COMMONWEALTH OF PUERTO RICO PUBLIC SERVICE REGULATORY BOARD PUERTO RICO ENERGY BUREAU

REVIEW OF THE PUETO RICO ELECTRIC POWER AUTHORITY INTEGRATED RESOURCE PLAN

CEPR-AP-2018-0001

Production of Documents in Response to Information Requests Made During IRP Evidentiary Hearings

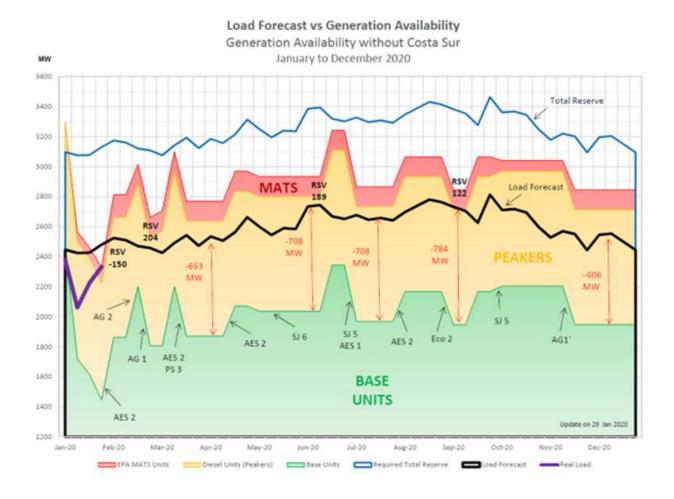
3) Energy Bureau: Detailed list of resources by unit behind the presentation of Panel A (Status of resources before and after the earthquakes - slide 20).

The following response was provided by Eng. Daniel Hernández, Director of the Generation Directorate, PREPA. Eng. Daniel Hernández certifies that, to the best of his information and belief, all answers provided by him herein are true and no false or misleading information has been provided.
